Recall Bulletin

SERVICE PARTS SAFETY RECALL

SUBJECT: Windshield Wiper Motor Failure

GM Recall #15789

4288474

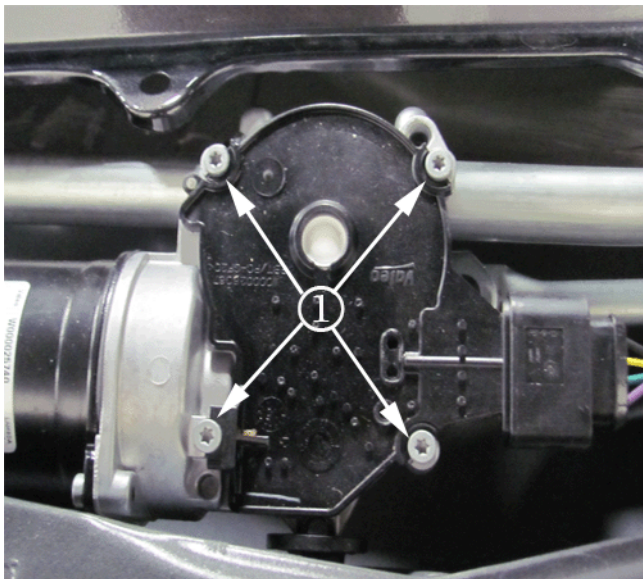
2. Verify the build date (1) printed on the label (2) of the wiper motor.
 - If the build date is between 15-08-15 and 18-09-15, proceed to step 3.
 - If the build date is NOT between 15-08-15 and 18-09-15, no further action is required. Reattach the air inlet grille panel.
3. Disconnect the wiper motor electrical connection.
4. If required, remove dirt, debris or moisture from the wiper motor cover.

4282666

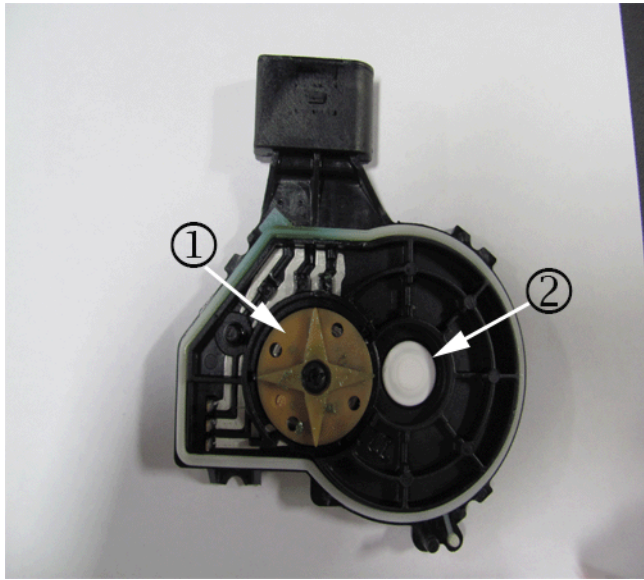
5. Remove the 4 wiper motor cover fasteners (1).
6. Remove the wiper motor cover.

4282670

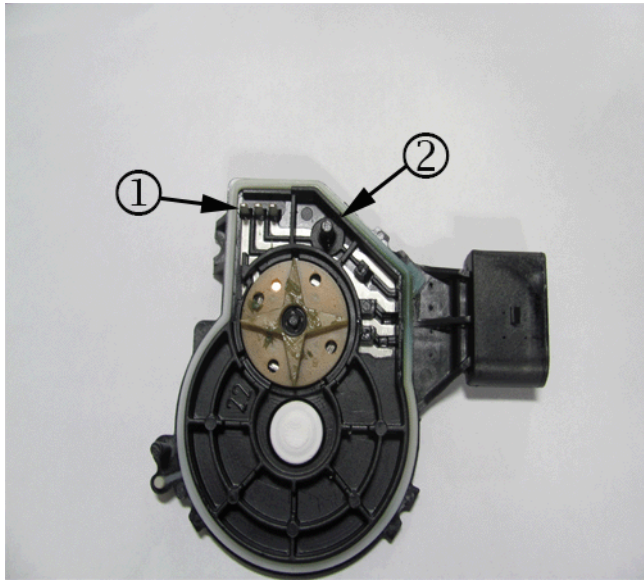
Caution: Damage may occur to the part if the sprocket is not aligned properly.

7. On the new wiper cover, align the sprocket (1) with the breather (2) as shown in the picture above.

4282676

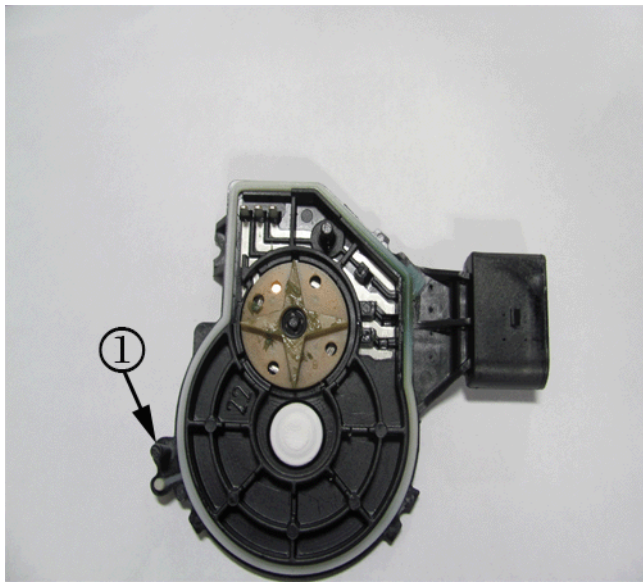
8. Install the new cover onto the motor starting with the terminals (1) and pin A (2).

4282680

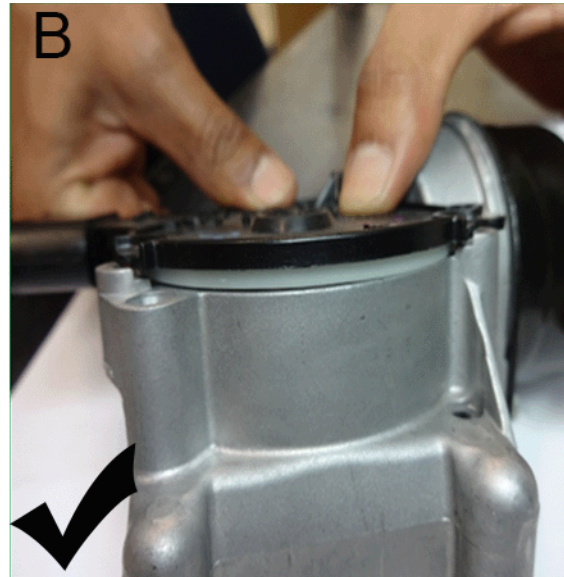
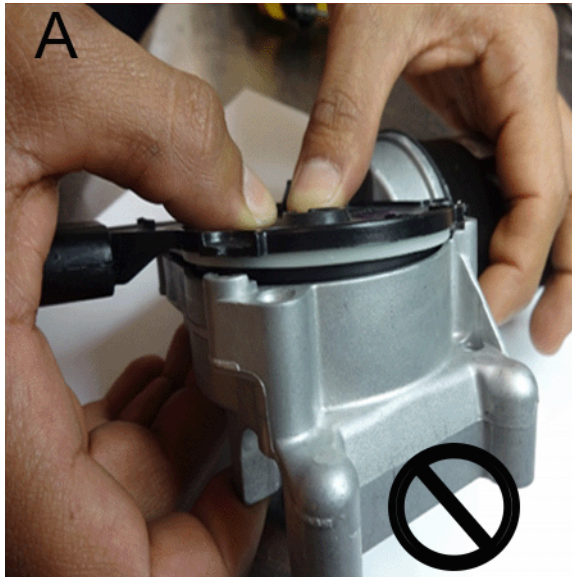
9. Push down carefully on the cover to align pin B (1).

10. Verify the cover lays flat on the motor assembly as shown in picture B.

4282687

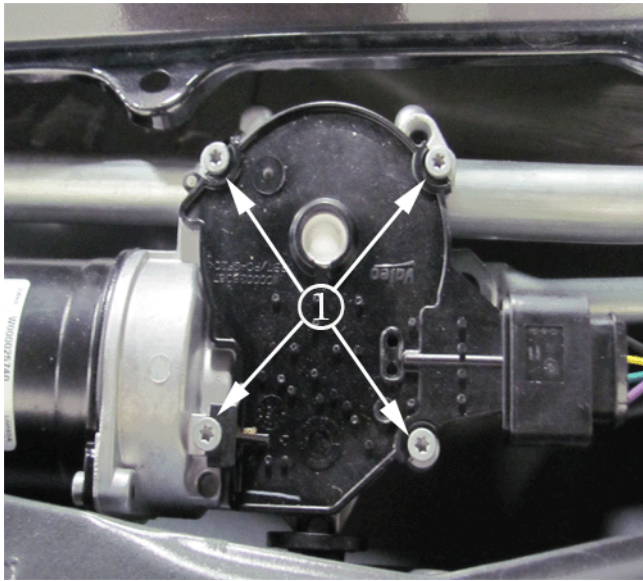
11. Tighten the 4 wiper motor fasteners (1) in a "X" pattern to 3.5 Nm (31 in lb). Verify the fasteners are bottomed out on the wiper motor casting.
12. Turn ON the ignition and verify wiper motor operation.
13. Turn OFF the ignition.
14. Install the air inlet grille panel. Refer to *Air Inlet Grille Panel Replacement* in SI.
15. Turn ON the ignition and verify wiper motor operation.
16. Turn OFF the ignition.
